D407-667-105
Job Sheet 164199

Part Name: Fwd Crosstube - High 407

DRAWING NO. D407-667-145
REV. C
SHEET 1 OF 4

DRAWING NO. D407-667-145	TITLE CROSSTUBE ASS'Y (407 HIGH FWD)	REV. C	DART AEROSPACE LTD ENGINEERING ORDER		D.E.O. NO. D407-667-145-C-1	SHEET NO. SHEET 1 OF 1	SCALE NTS
DRAWN <i>qp</i>	CHECKED <i>ASS</i>	MFG. APPR. <i>is</i>	APPROVED <i>WD</i>		DE APPR. <i>is</i>		
DATE 11.07.15	DATE 11.07.22	DATE 11.07.22	DATE 11/07/22		DATE 11.07.21

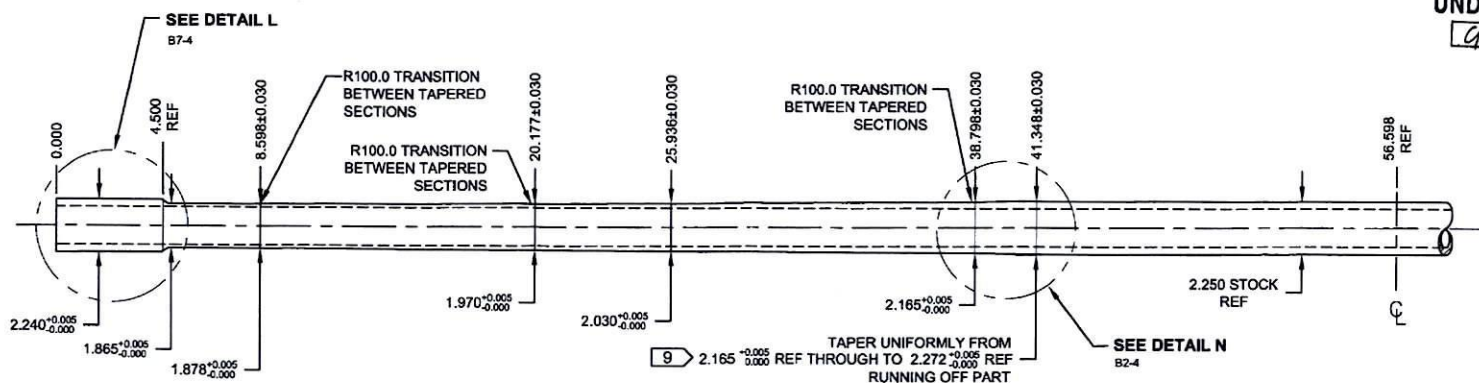
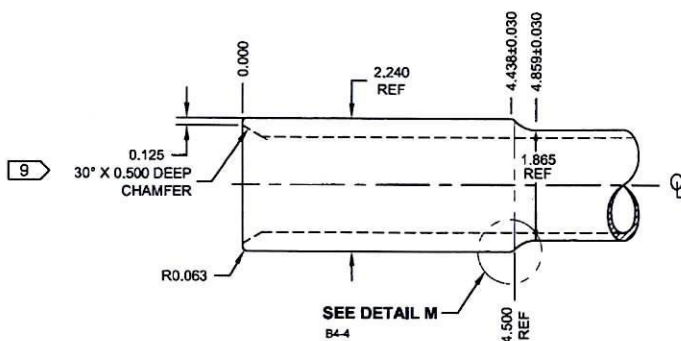
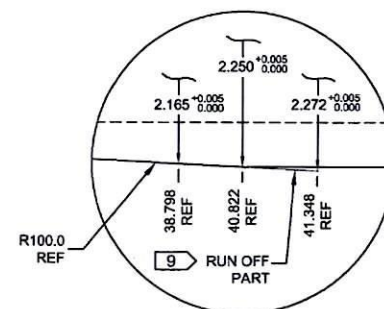
DEO ATTACHED

DRAWING NO. D407-667-145	TITLE CROSSTUBE ASS'Y (407 HIGH FWD)	REV. C	DART AEROSPACE LTD ENGINEERING ORDER	D.E.O. NO. D407-667-145-C-2	SHEET NO. SHEET 1 OF 1	SCALE NTS
DRAWN AJS	CHECKED	MFG. APPR.	APPROVED	DE APPR.		
DATE 12.08.02	DATE 12.08.02	DATE 12.08.02	DATE 12.08.02	DATE 12.08.02	DATE 12.08.02

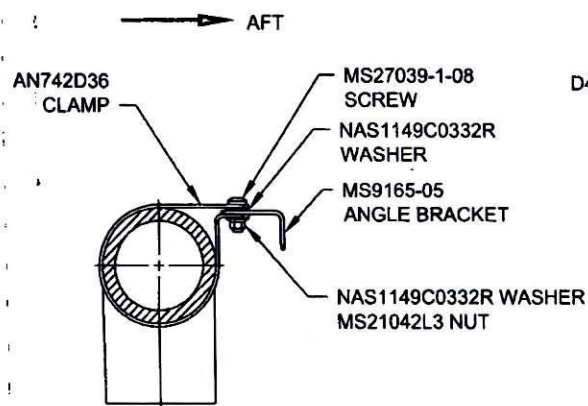
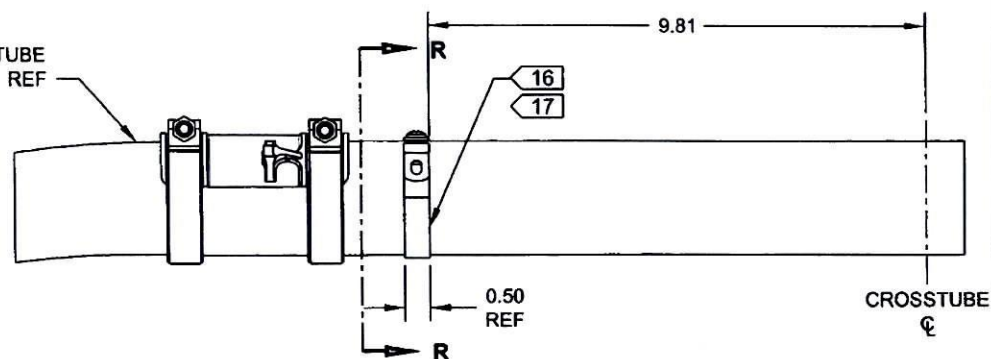
ADD ELECTRICAL GROUNDING STRAP

ITEM	QTY	PART NUMBER	DESCRIPTION
1	X	D407-667-145	CROSSTUBE ASSEMBLY (407 HIGH FWD)
10	2	AN742D36	CLAMP
11	2	MS9165-05	ANGLE BRACKET
12	2	MS21042L3	NUT (OR MS21042-3)
13	2	MS27039-1-08	SCREW
14	4	NAS1149C0332R	WASHER (OR AN960C10L)
